**UNITED STATES DEPARTMENT OF COMMERCE  
Patent and Trademark Office**

# Office Action Summary

09/115,764

REASONER

FIG. 4

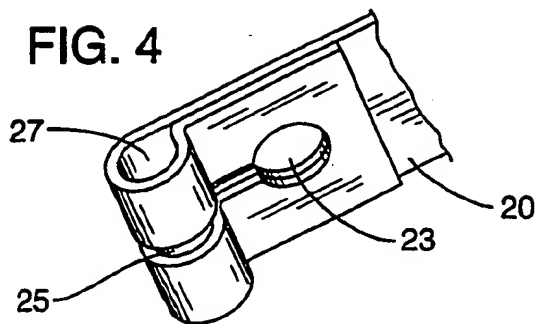
1. The drawings are objected to under 37 CFR 1.83(a). The drawings must show every feature of the invention specified in the claims. Therefore, the claimed features such as: (a) the overall length of the first and second conduit sections, and the shortening of the overall length of the first and second conduit sections in claims 1 and 17-19; and (b) the *shortest* overall length of the conduit in claim 15 must be shown, *or the features canceled from the claims. No new matter should be entered.*

Note that Figs. 1, 3 and 4 merely show portions of the first and second conduit sections 14 and 16, not their overall length. The shortening and the shortest overall lengths of the conduit sections are required to be shown in accordance with 37 C.F.R. 1.84(h), *or the features canceled from the claims.*

NOTE THAT L1 IS SHORTER THAN L2 AS MEASURED BY A RULER  
EXHIBIT

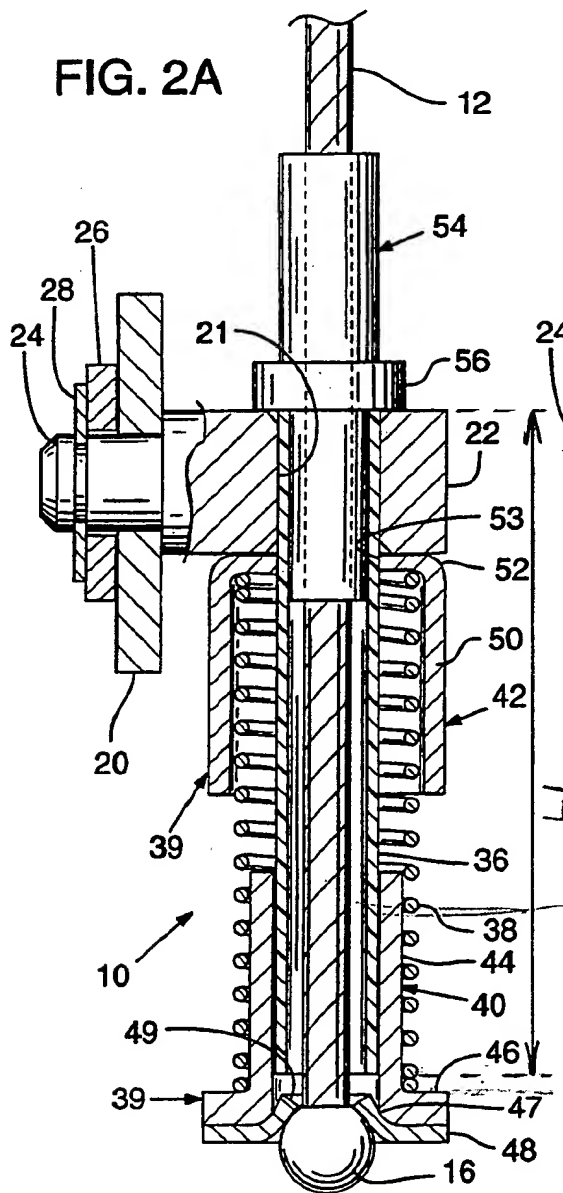
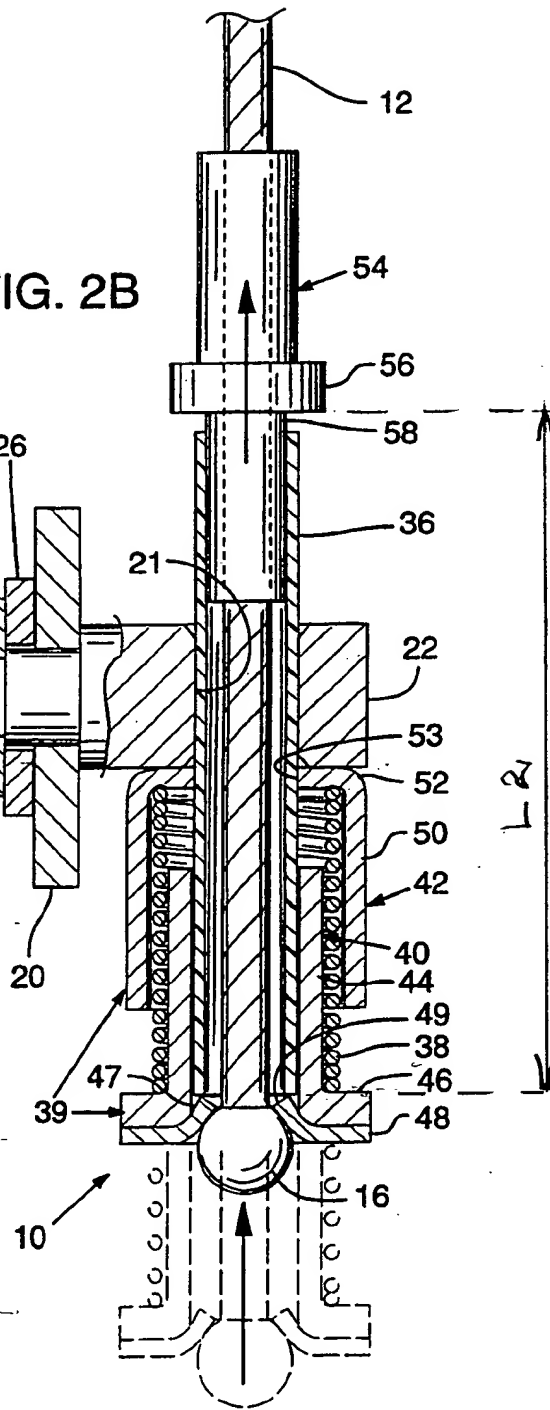
(a) Fig. 2B shows that as the spring 38 is compressed axially, the first conduit 36 is pulled and the second conduit 58 (i.e., the fitting 54) moves away, consequently, the

(b) Fig. 2B shows that as the spring 38 is expanded axially, the first conduit 36 is retracted backwardly and the second conduit 58 (i.e., the fitting 54) moves forwardly until the fitting 54 is stopped by the pivot coupling 22, consequently, the overall length of the conduit sections 36 and 58 are shortened. See lines 47-53 of column 7.

For applicant's convenience, the examiner attached the Exhibit wherein L1 is the overall length of the first and second conduit sections 36 and 58 when the spring is expanded (Fig. 2A), and L2 is the overall length of the first and second conduit sections 36 and 58 when the spring is compressed (Fig. 2B). Applicant is respectfully advised to use a ruler and measure the lengths of L1 and L2. Applicant would recognize that L1 is shorter than L2. It has long been settled law that a claimed invention may be anticipated or rendered obvious by a drawing in a reference, whether the drawing disclosure is accidental or intentional. *In re Meng*, 181 U.S.P.Q. 94, 97 (CCPA 1974) and *In re Mraz*, 173 U.S.P.Q. 25 (CCPA 1972). On the other hand, the functional limitations of a claim may not be given patentable weight where those limitations are inherent in a prior art reference. *In re Schreiber, supra*.
